City of Alachua

Planning & Community Development Department Staff Report

August 26, 2019

SUBJECT:	A request for a Zoning Variance Permit from certain standards as set forth in Section 6.5, Signage, of the City of Alachua Land Development Regulations
APPLICANT/AGENT:	Clay Sweger, AICP, LEED AP, EDA Engineers – Surveyors – Planners, Inc.
PROPERTY OWNER:	The Laser Investment Group, LLC
LOCATION:	13025 NW US Highway 441, east of the intersection of NW US Highway 441 and NW 89 th Street
PARCEL ID NUMBERS:	05962-002-000; 05844-004-001; 05855-005-000
FLUM DESIGNATION:	Corporate Park
ZONING:	Corporate Park (CP)
OVERLAY:	N/A
ACREAGE:	±82.00 acres
RECOMMENDATION:	Staff recommends that the Board of Adjustment approve the Zoning Variance Permit, subject to the four (4) conditions provided in Exhibit “A” of this Staff Report.
RECOMMENDED MOTION:	<i>Based upon the competent substantial evidence presented at this hearing, the presentation before this Board, and Staff's recommendation, this Board finds the application to be consistent with the City of Alachua Comprehensive Plan and in compliance with the Land Development Regulations and approves the Zoning Variance Permit, subject to the four (

Illustration 1: Proposed Freestanding Sign with Sign Detail (Submitted by Applicant)

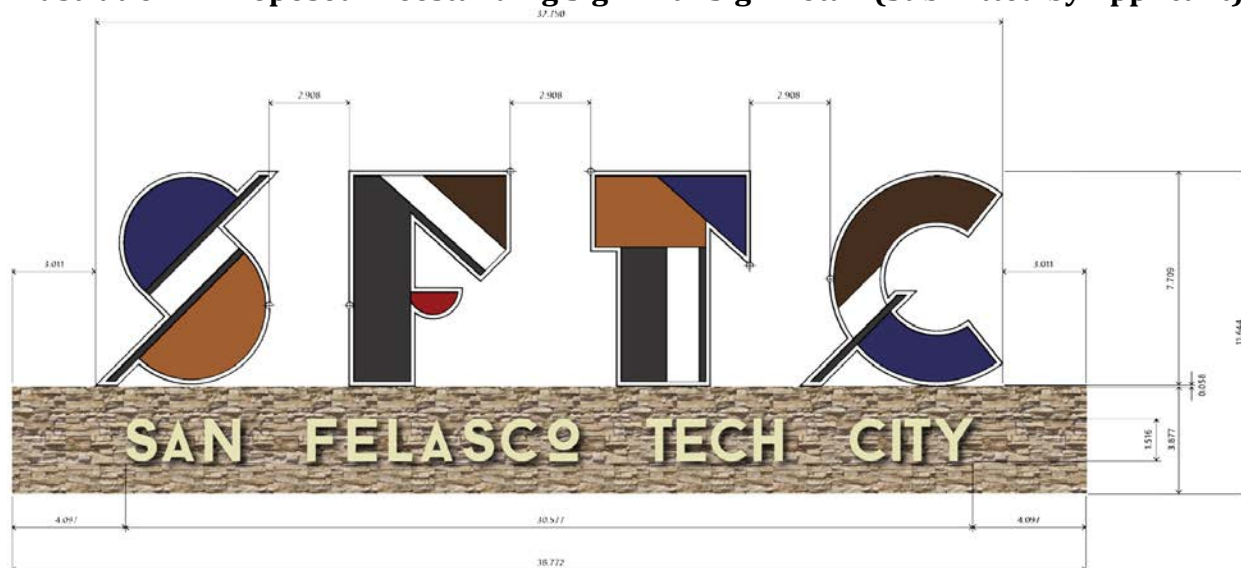
- ❖ A variance from Section 6.5.4(C)(2)(d) of the LDRs, to allow one (1) freestanding sign with an area which shall not exceed 402.79 square feet (for the sign and its structure), and with a sign area which shall not exceed 298.825 square feet. The LDRs require that, for multi-tenant buildings and developments, the maximum sign area of a freestanding sign and its structure cannot exceed 150 square feet, and the maximum area of an individual sign face cannot exceed 100 square feet.

- ❖ A variance from Section 6.5.4(D)(1)(c) of the LDRs, to allow one (1) freestanding sign which shall not exceed 38.772 feet in length. The LDRs require that, for freestanding signs in business districts, the maximum width of a freestanding sign is 16 feet.

- ❖ A variance from Section 6.5.4(D)(3)(d) of the LDRs, to allow one (1) freestanding sign to be located closer than 15 feet to existing stormwater infrastructure. The LDRs state that signs are not permitted to be within 15 feet of any stormwater infrastructure.

Illustration 5: Excerpt of Sheet C4.00, Utility Plan – Approved Site Plan SFTC Phase 1

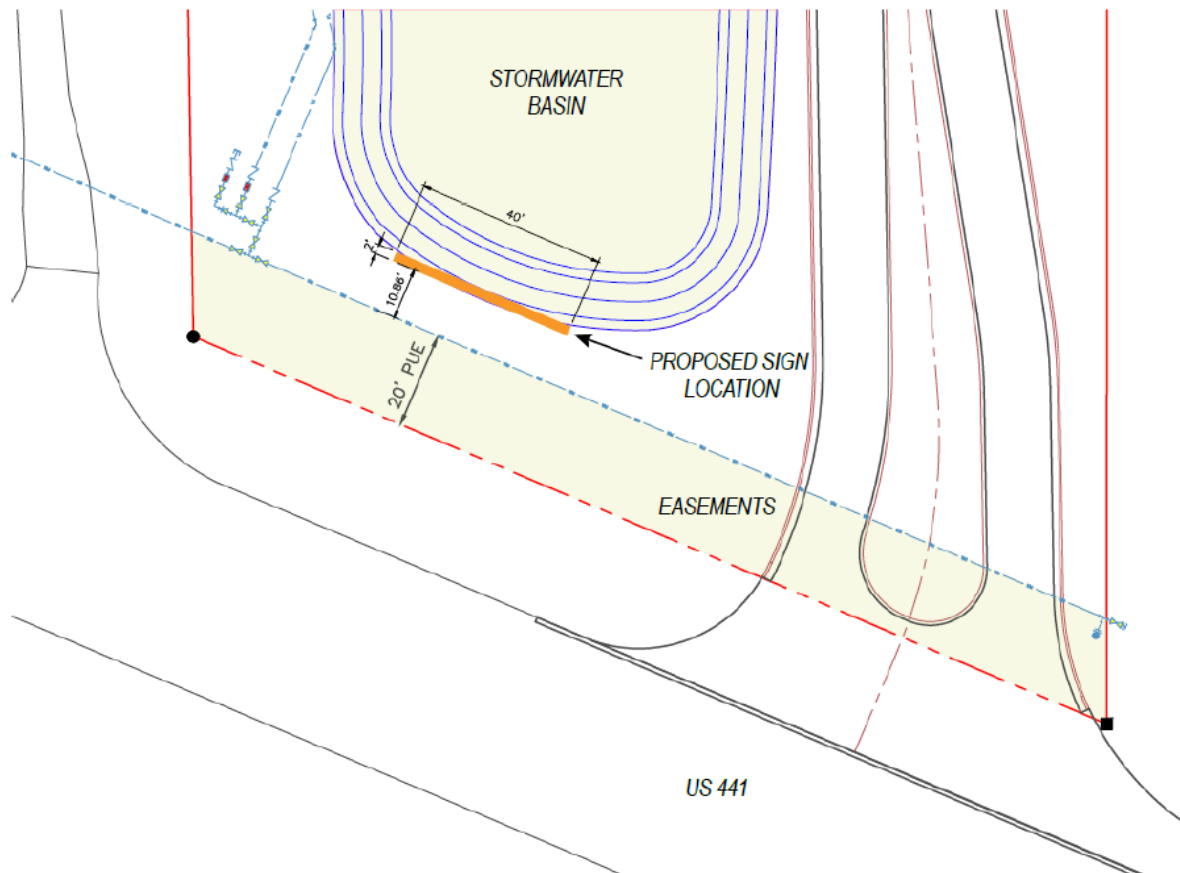
While the applicant states in its justification report that the stormwater basins "... are designed for the low point on the site [and must] be located where it is permitted on the plans...", Staff finds that it may have been possible for the applicant to have approached the design of and location of the stormwater basin and potential locations for a freestanding sign for the SFTC project more holistically. However, the stormwater basin is privately maintained, and is the responsibility of the property owner. Any potential issues which could result from locating the proposed sign immediately adjacent to the stormwater basin (such as canting of the sign or erosion around the base of the sign) would be the responsibility of the property owner to address.

The sign complies with the minimum separation requirements from all public utilities (water and wastewater facilities) as set forth in Section 6.5.4(D)(3)(d) (ten (10) feet from water or electric system infrastructure and 15 feet from wastewater infrastructure). See Illustrations 4 and 5 above, which depict the location of a 20 foot Public Utilities Easement and the location of public utilities as shown on the approved Site Plan for Phase 1 of San Felasco Tech City, respectively.

Since the stormwater basin is not publicly maintained, the proposed location of the sign would not result in any responsibility of the City to address any potential issues which may arise from the location of the sign immediately adjacent to the stormwater basin.

EXHIBIT “B”
TO
SAN FELASCO TECH CITY
ZONING VARIANCE PERMIT
SECTION 6.5, SIGNAGE

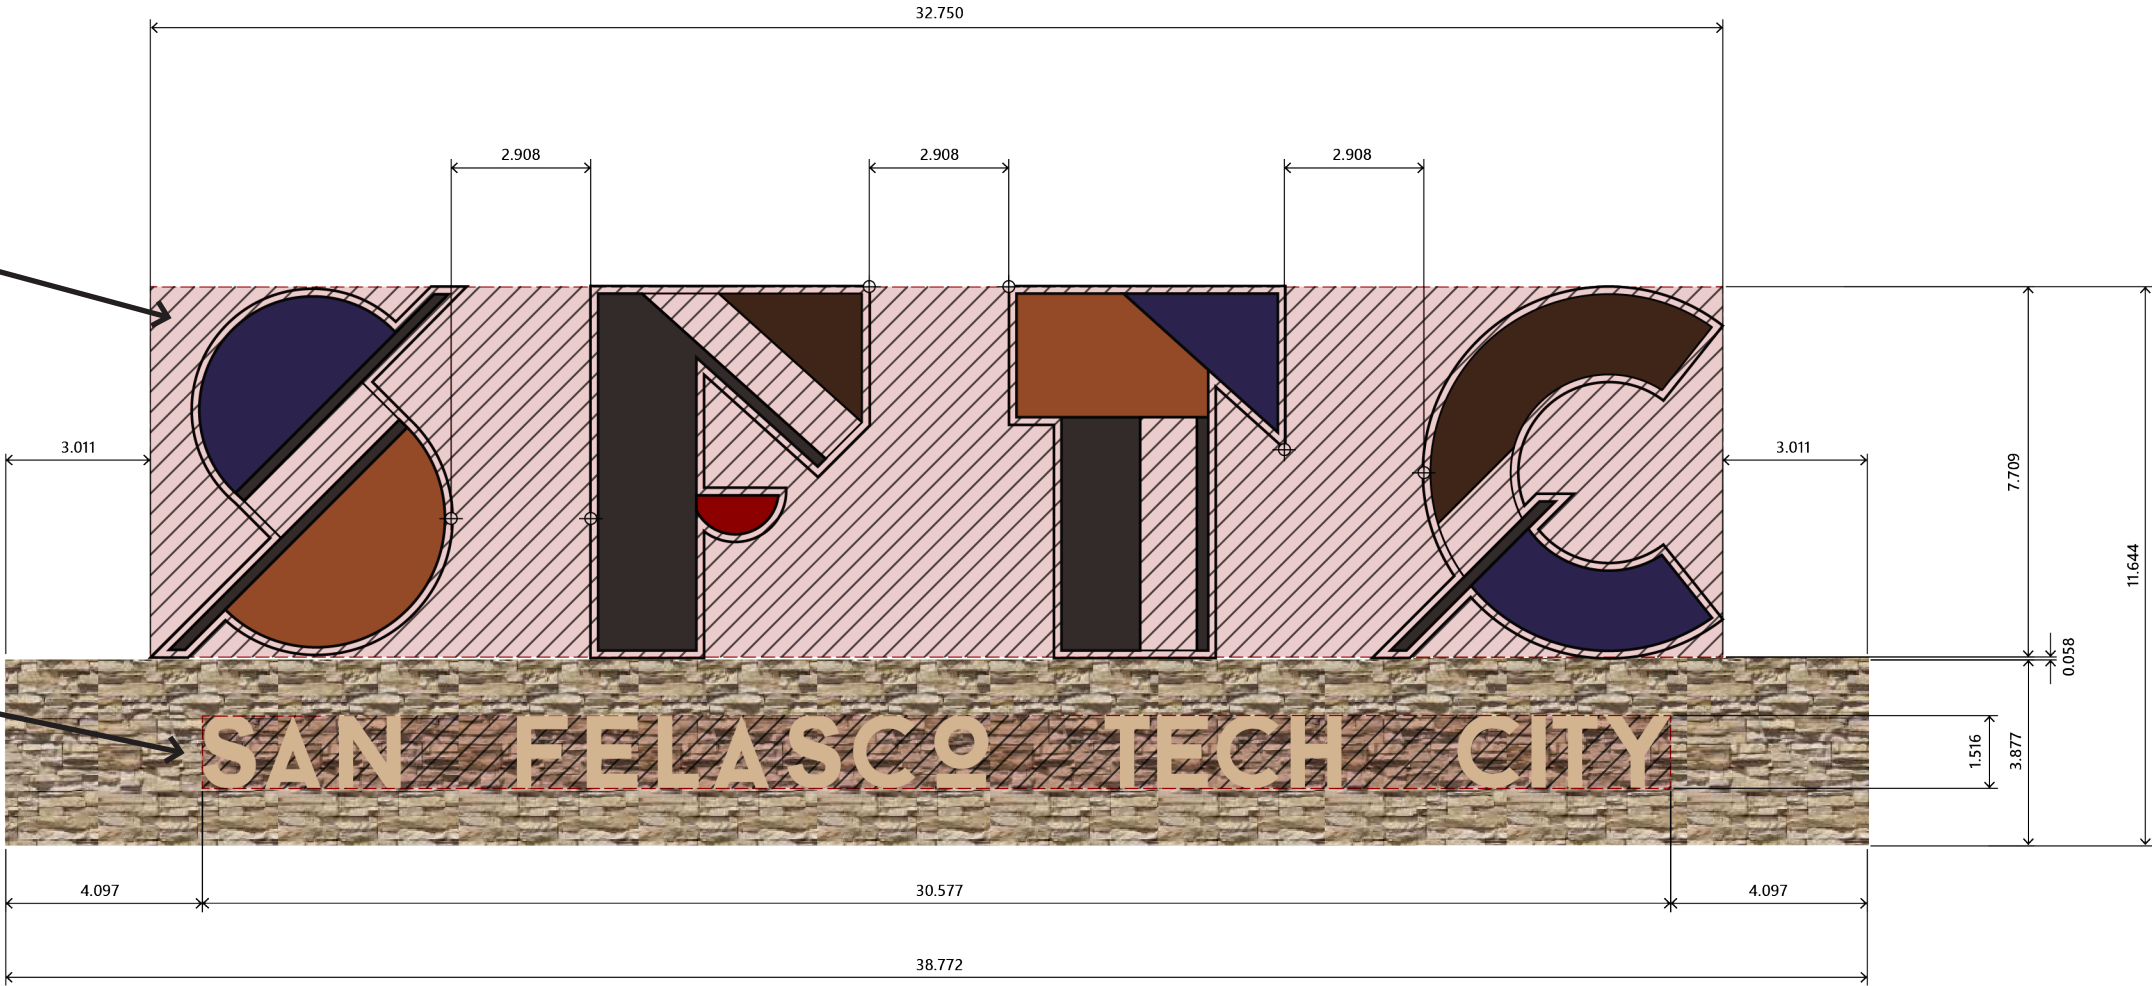
3. The applicant acknowledges and agrees that the project’s one (1) freestanding sign located adjacent to the US Highway 441 frontage shall be consistent with the exhibit contained on Page 1 of Exhibit “B” – Staff Supporting Materials – of the August 26, 2019 Staff Report to the Board of Adjustment, which depicts the proposed freestanding sign as submitted by the applicant.
